DEVELOPMENT APPLICATION ASSESSMENT REPORT

Application Number:	DA2018/1994
----------------------------	-------------

THAT Council as the consent authority grant Development Consent to DA2018/1994 for Construction of a dwelling house on lot 7 of proposed subdivision on land at Lot 9 DP 629464, 104 Cabarita Road, AVALON BEACH, Lot 8 DP 629464, 102 Cabarita Road, AVALON BEACH, Lot 15 DP 858130, 100 Cabarita Road, AVALON BEACH, Lot 14 DP 858130, 96 Cabarita Road, AVALON BEACH, subject to the conditions printed below:

North-East Elevation - Side boundary envelope non-compliance (source: Mark Hurcum Architects)

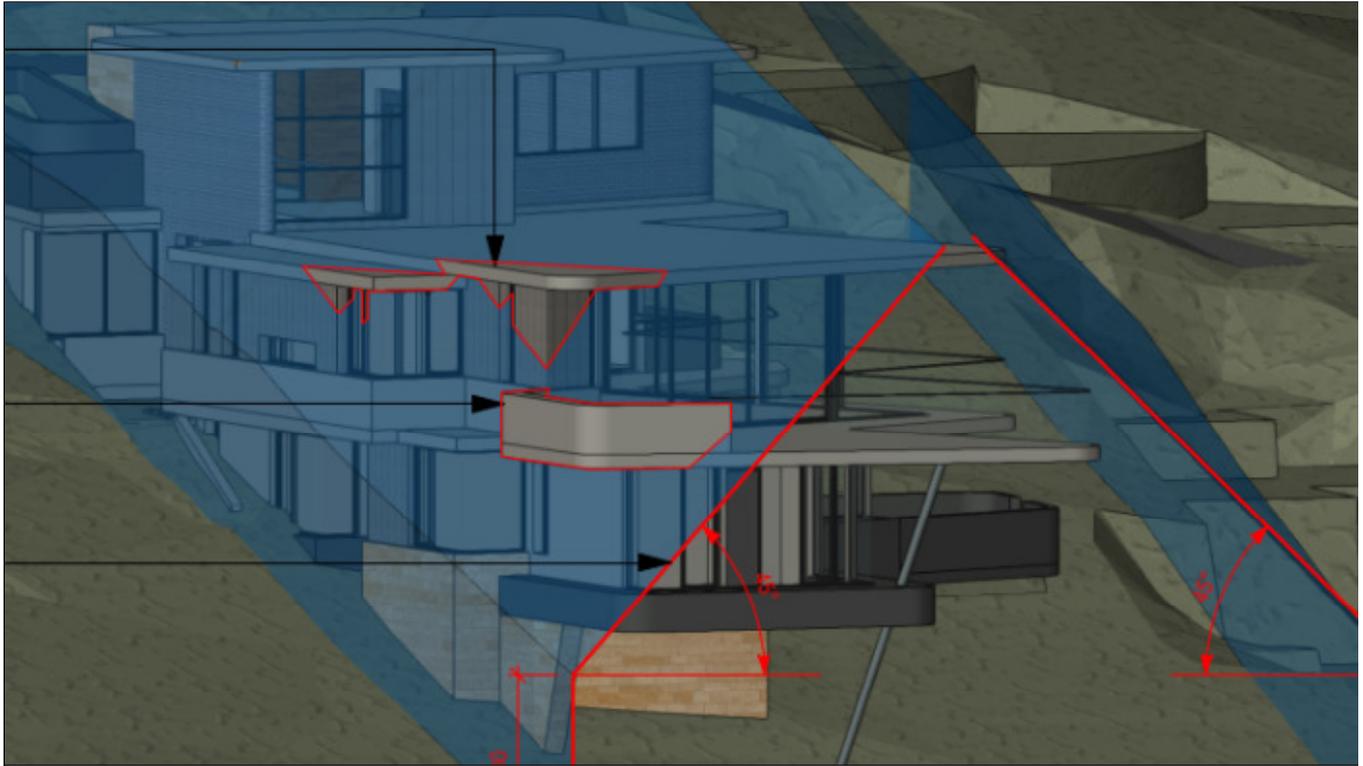
The proposed development results in a number of small non-compliances with the building envelope along the south-eastern elevation. Accordingly, the proposal is considered against the underlying Outcomes of the control.

As such, it is recommended that the proposal be supported on merit, despite the technical noncompliance with the building envelope control.
